EASTSIDE PUMP STATION REPLACEMENT OF PUMPS 1 AND 2

CITY OF ROCKWALL, TEXAS
EASTSIDE PUMP STATION
REPLACEMENT OF PUMP NOS. 1 AND 2

ADDENDUM NO. 1
April 13, 1999

CITY OF ROCKWALL, TEXAS
EASTSIDE PUMP STATION
REPLACEMENT OF PUMP NOS. 1 AND 2
CHANGE ORDER NO. 1

REVISED ONE LINE DIAGRAM

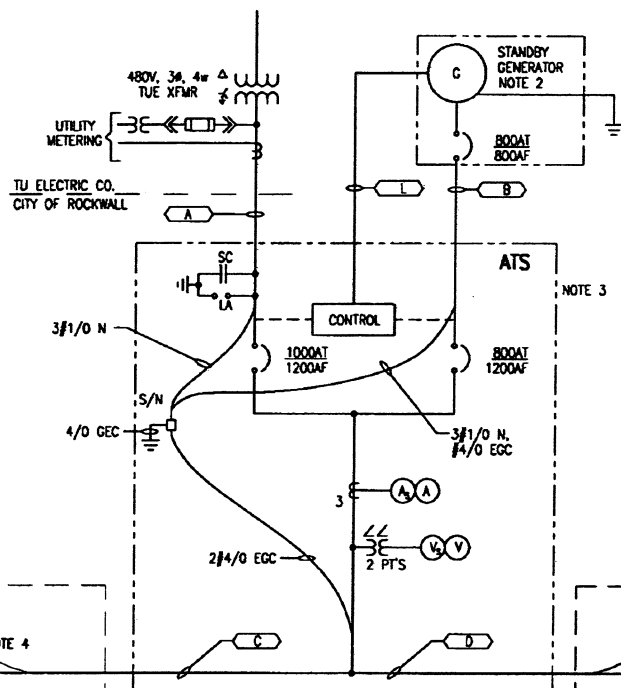
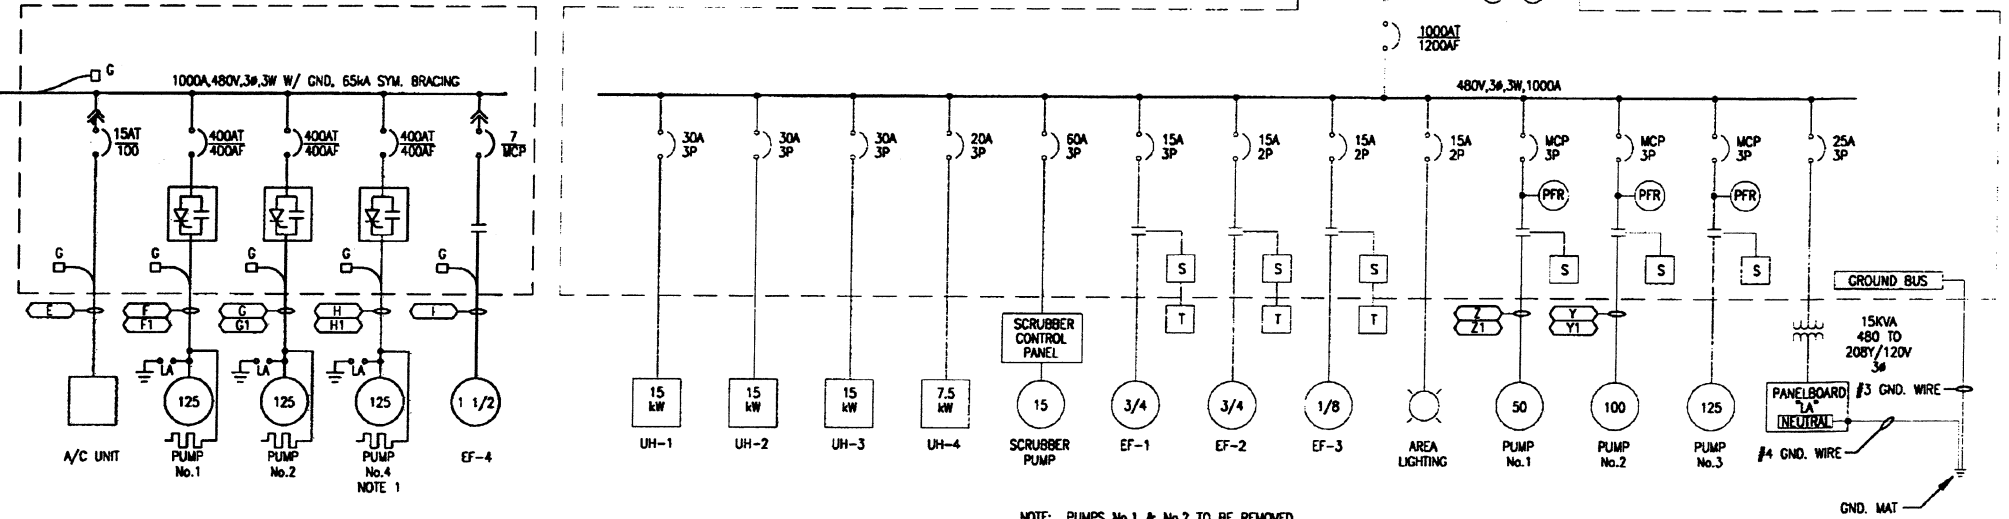
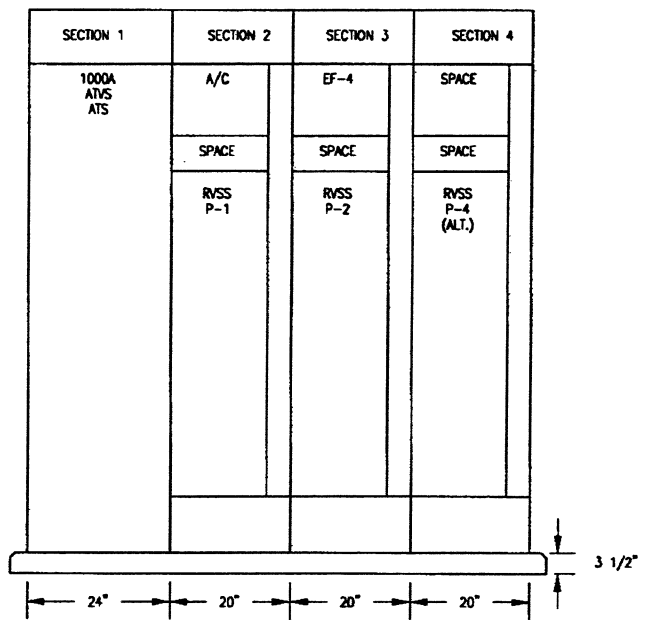
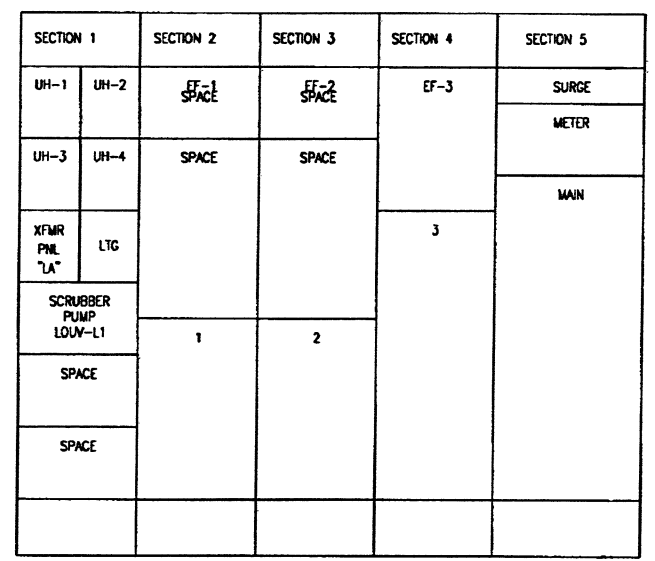
- DRAWINGS
- Refer to Drawing E1, Sheet 7. Revise One Line Diagram as follows:
 - Add Note 5. Provide a sign at Service Entrance Panel indicating the location of Both Sources of Power.

- Make the A/C Unit Circuit Breaker 15 Amps.
 - Add a Heavy Duty 480 Volt, 30 Amp, Non-fused Safety switch to the A/C Unit One Line Drawing.
 - Refer to Drawing E2, Sheet 8.

EASTSIDE PUMP STATION
ELECTRICAL SITE PLAN

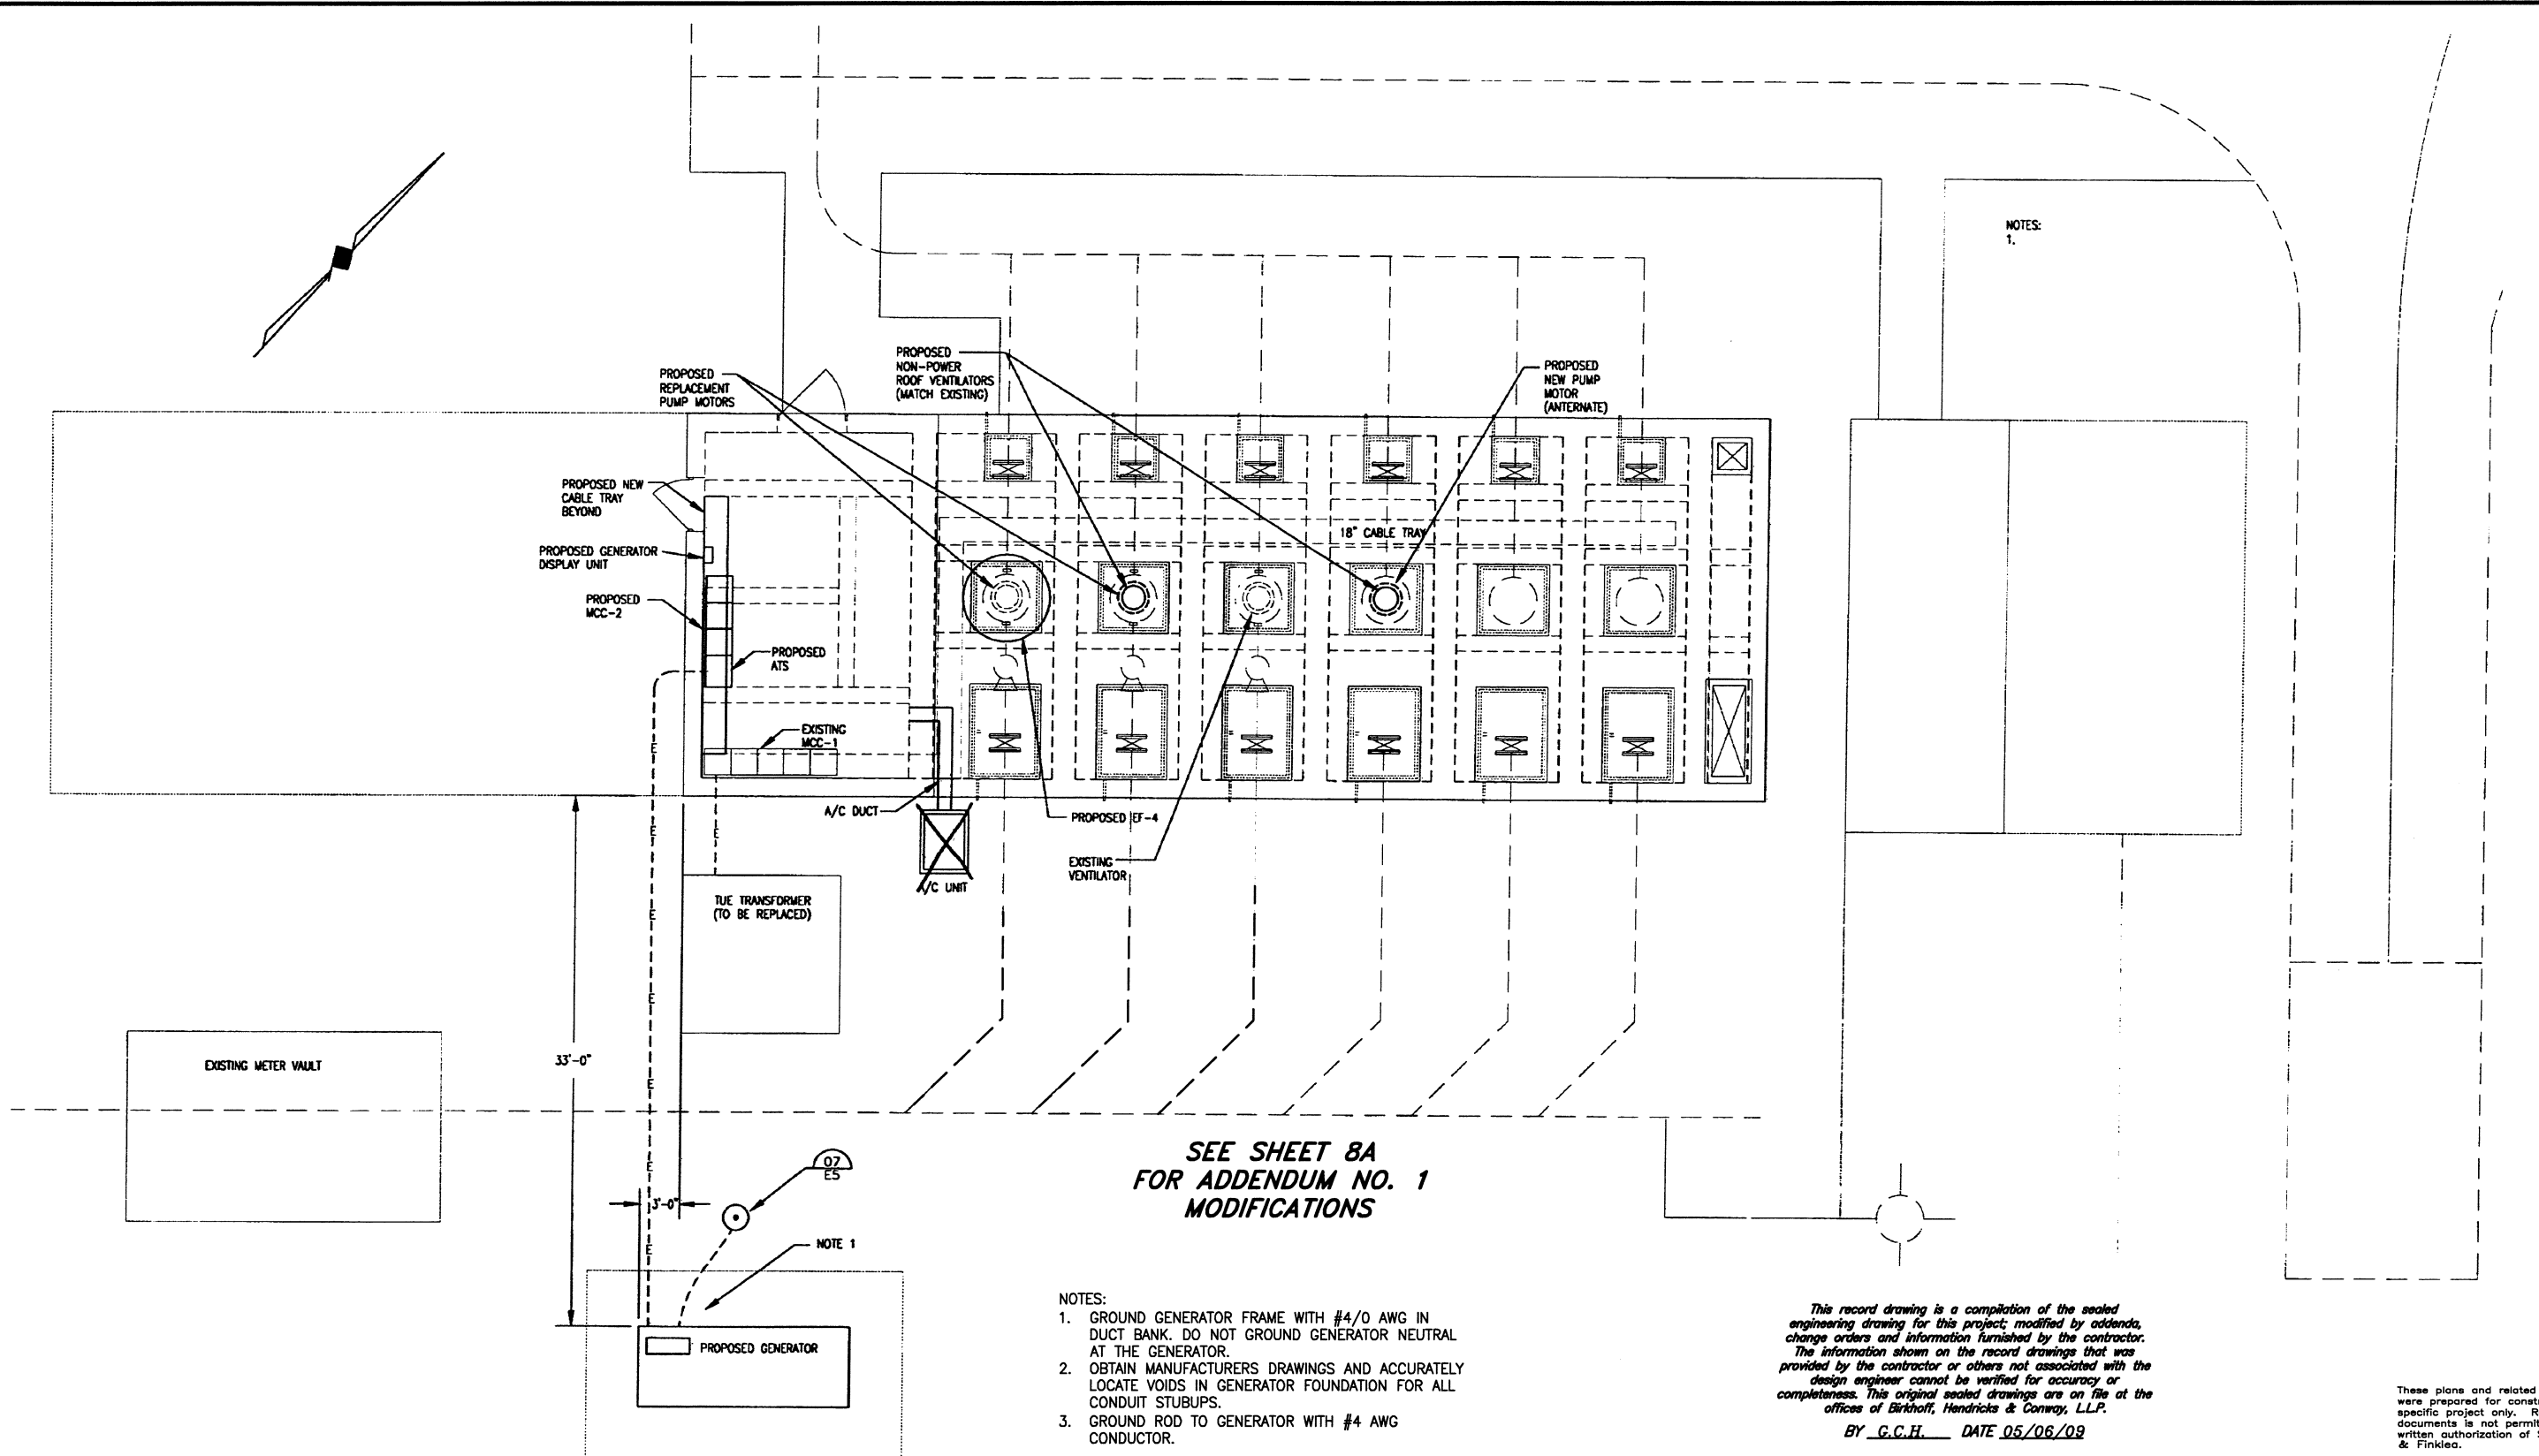
- Add the following notes to this sheet:
Note 1: Ground Generator Frame with #4/0 AWG in Duct Bank. Do not ground Generator Neutral at the Generator.
Note 2: Obtain Manufacturers drawings and accurately locate voids in generator foundation for all conduit stubups.
Note 3: Ground Rod to Generator with #4 AWG Conductor.

- Delete A/C location on plan. Refer to attached Air Conditioning Sheets for A/C Unit Location and details.
 - Refer to Drawing E3, Sheet 9.
 - Add the Thermostat near EF-4 to control the Exhaust Fan when the motor control selector switch is in the auto position.

CITY OF ROCKWALL, TEXAS		
EASTSIDE PUMP STATION AIRCONDITIONING UNIT REVISIONS		
SHIMEK, JACOBS & FINKLEA, L.L.P. CONSULTING ENGINEERS Dallas, Texas		
DESIGNED BY: <u>J. A. FRY</u>	PROJECT: <u>98 192</u>	SHEET NO. <u>8A</u>
DRAWN BY: <u>R. E. BRADY</u>	DATE: <u>APRIL 1999</u>	OF <u>12</u> SHEETS

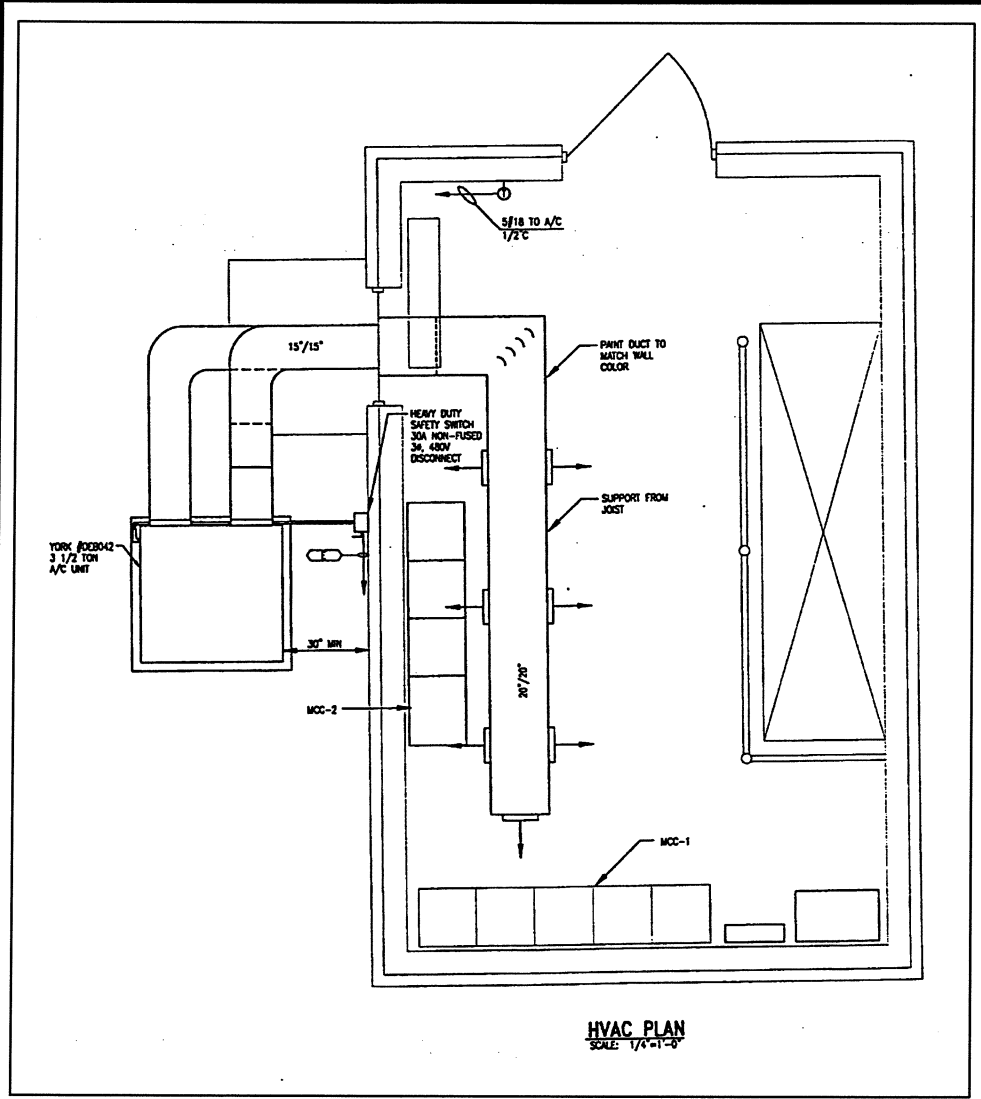
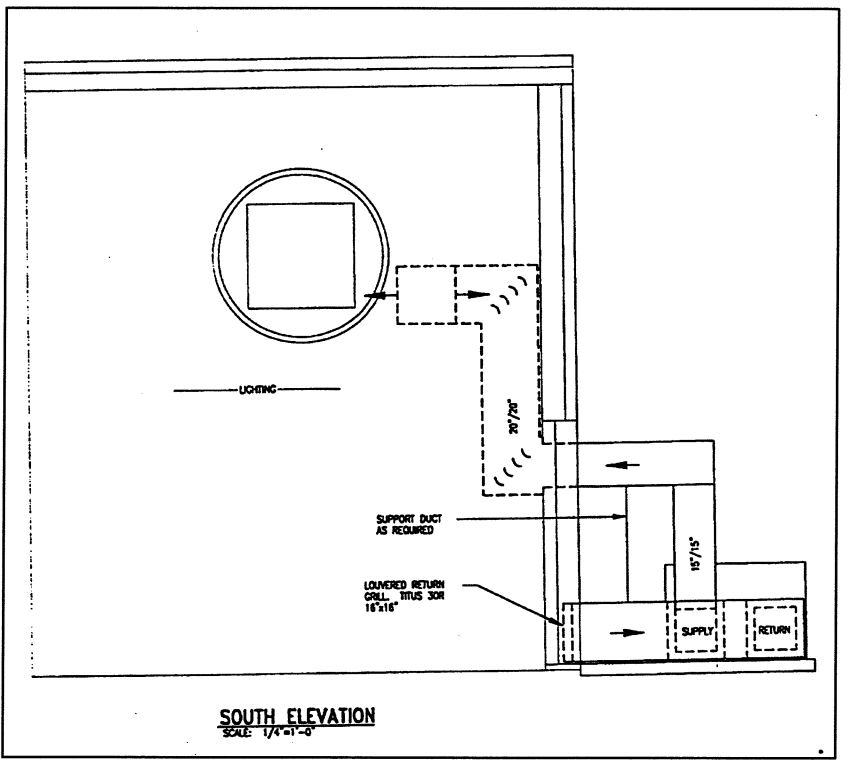
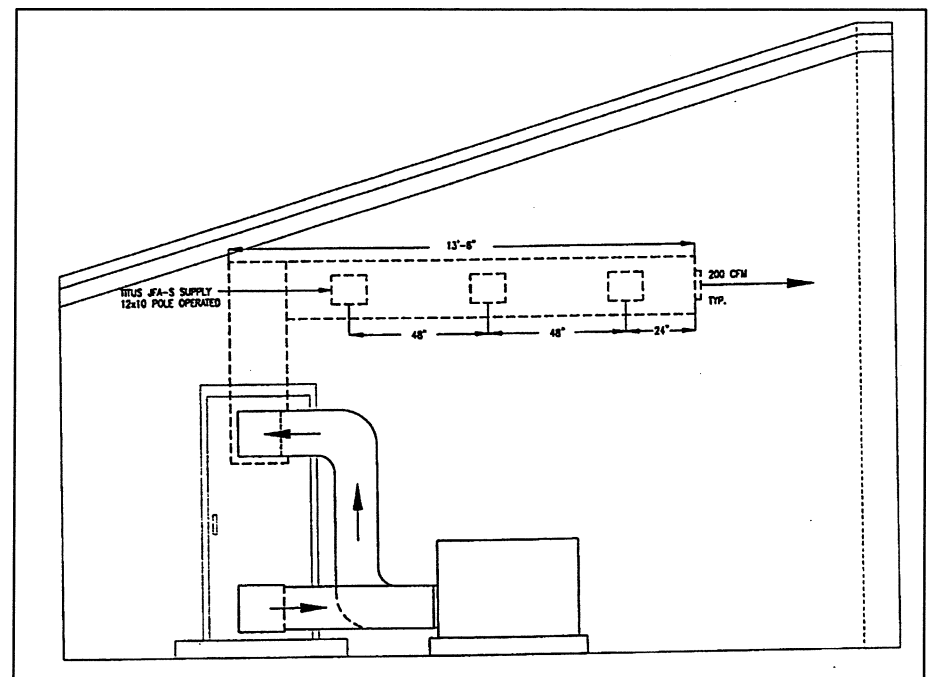
D. Provide and install 480V-3Ø room air conditioner to replace existing window unit. Unit shall be rated at 3½ tons with 115° air on outdoor coil. Unit shall have a SEER rating of 10 or higher. York single package slab on ground with insulated and weather protected outdoor duct and distribution through existing door. Unit will be cooling only. Provide thermostat and all controls. Paint indoor duct to match. Provide York model DEB04Z or equal.

SECTIONAL PLAN
SCALE: 3/8"=1'-0"

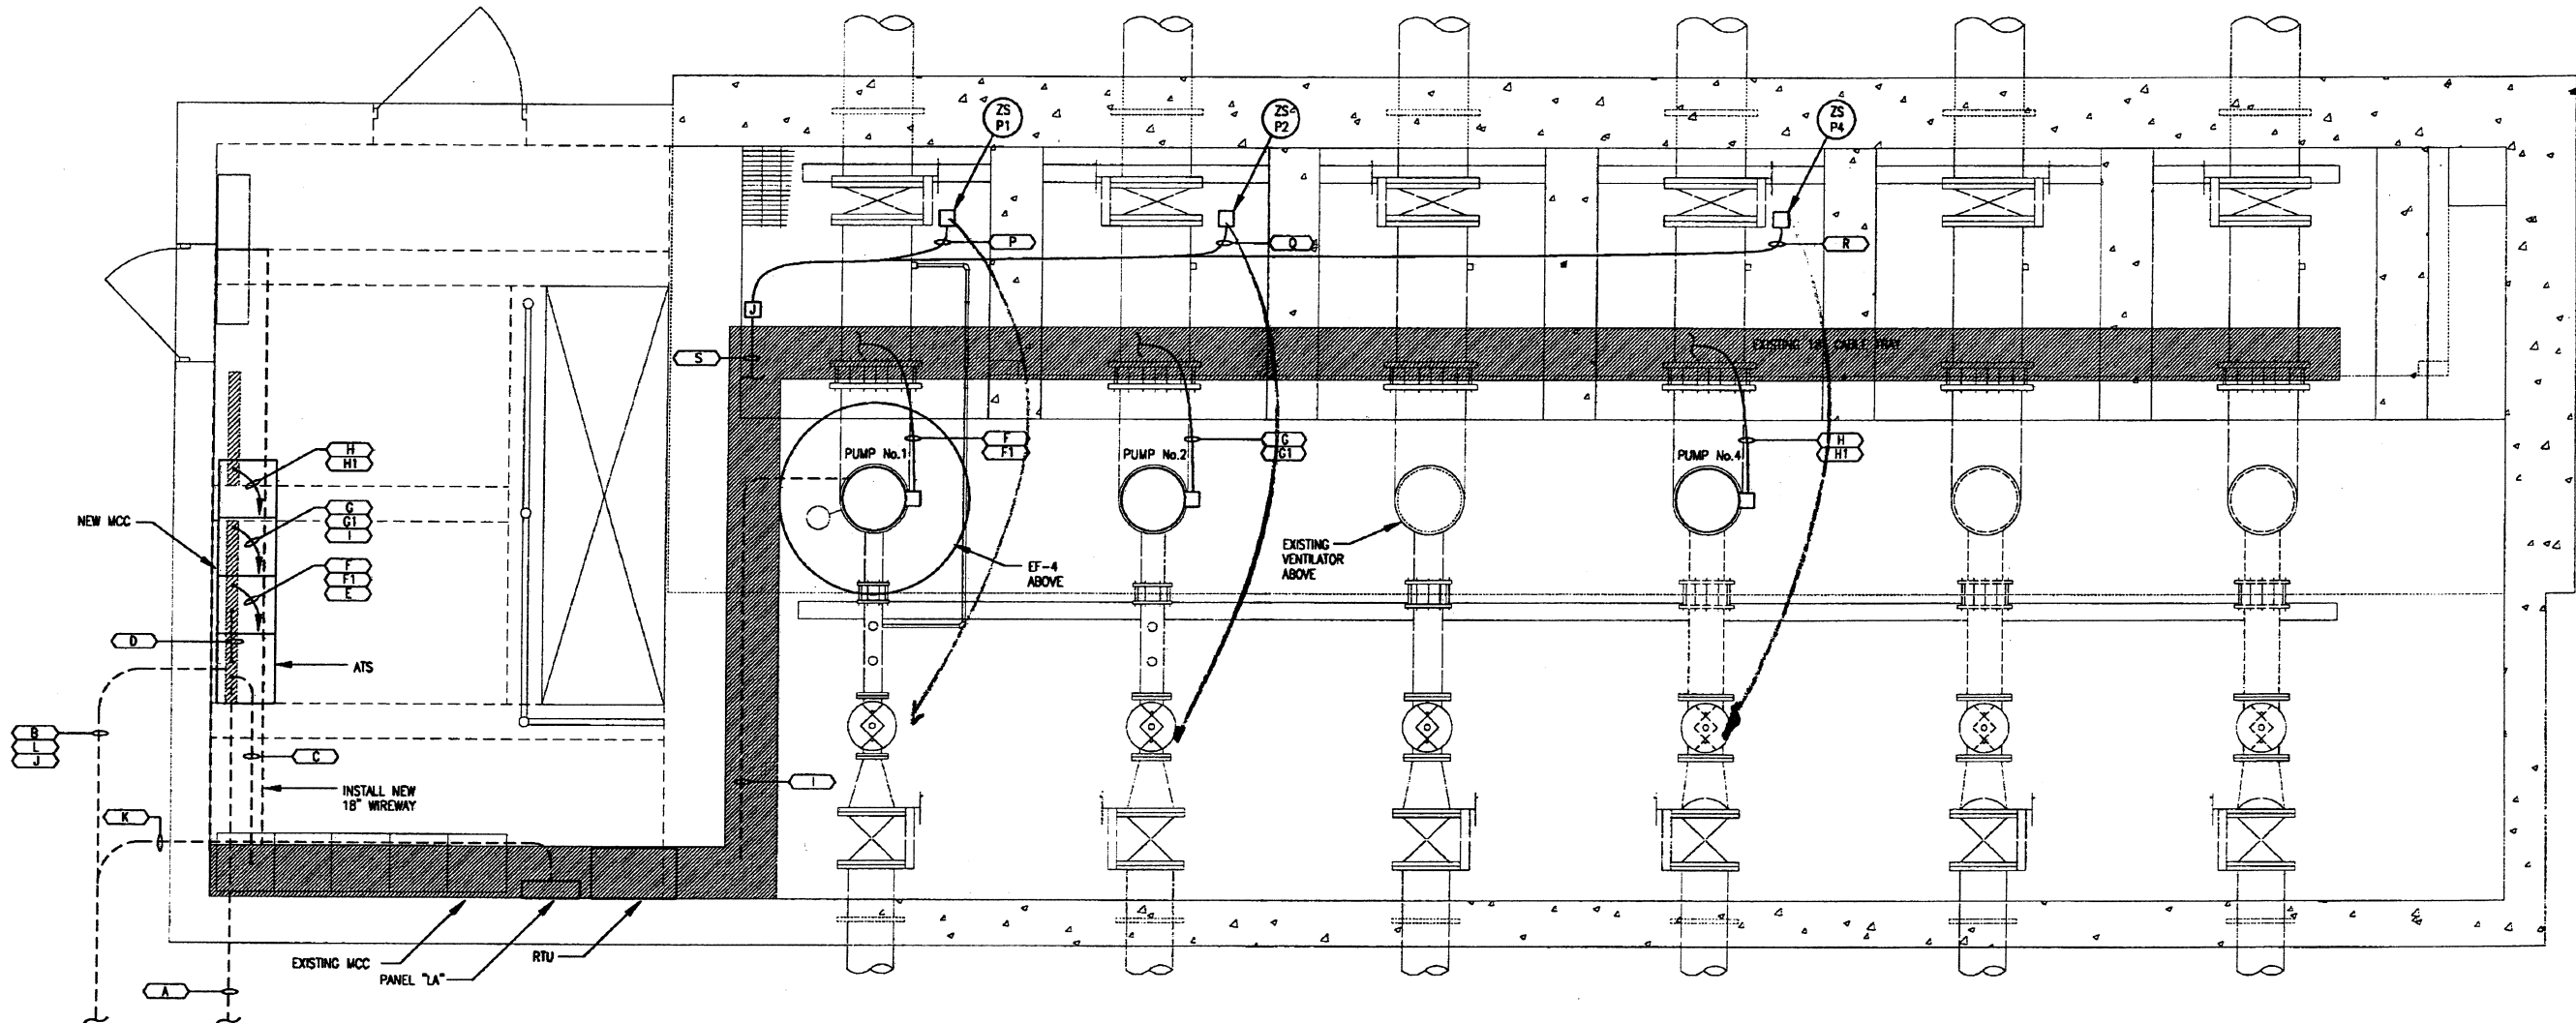
- Move all three valve closed position switches (ZS P1, P2 and P3) to the pump discharge valves.
 - Add Note 2: Contractor shall demolish existing unused pump control valve wiring to Pump Nos. 1 and 2.
